**ITEM #2 - PRELIMINARY PLAT
HUMPY POINT SUBDIVISION**

KPB File No.	2024-052
Plat Committee Meeting:	June 10, 2024
Applicant / Owner:	Kenai Peninsula Borough
Surveyor:	Jason Schollenberg – Peninsula Surveying, LLC
General Location:	Kalifornsky Beach Area, Kasilof, Alaska

STAFF REPORT

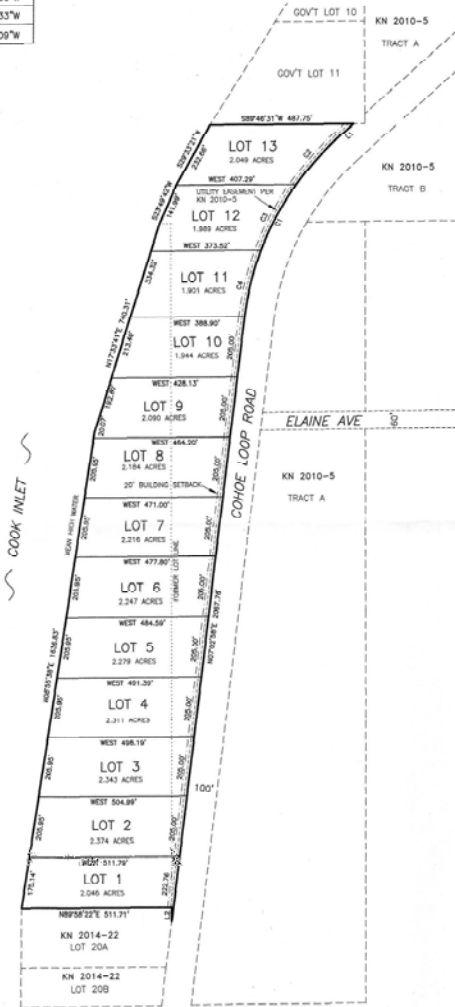
The plat is not completing a vacation or dedication of right-of-way with this action. The plat is not affected by a section line easement but is affected by a trail easement created by Patent 18756. The trail is located near the center of Lot 12 and is 25 feet wide. **Staff recommends** the surveyor locate the trail and either identify the easement on the trail or create a plat note to mention the trail easement.

There is also a 5 foot wide surveyor easement located along vacated government lot 12 line as identified on 2010-6 and each monument noted. Surveyor should identify and note this easement also.

The 50 foot access easement granted by the patent 18756 needs shown along the western side of the plat. the surveyor needs to identify the limits of the easements and show and note this easement on the plat.

There are areas of steep slope greater than 20% on the west side of the proposed parcels along the Cook Inlet. **Staff recommends:** These areas be depicted with top and toe of slope or indicate slope and direction on the final plat.

There are 10' utility easements along the existing right-of-way dedications that are correctly depicted on the plat. The 5' utility easement at the boundary lines of the lots extending to the 20' setback need to be added.

Correct KPB file number to 2024-052.

Verify overall acreage lots total slightly more than total given

In the legal add the section, township, range, meridian and Alaska behind the government lots.

Show 50' public access easement entire length of boundary with inlet in Patent 18756.

Show the trail on the drawing as shown on Detail C of 2010-5. Add the 25' public access easement listed in Patent 18756 to trail or note in plat notes

Tract D to the east should be labeled correctly.

Place top and toe of steep slope or indicate slope and direction on the drawing.

Report and engineer signature needed.

Indicate record measurements and add legend.

Check overall acreage and verify closure.

Indicate markers set and add legend.

Indicate markers set, record measurements and add legend.
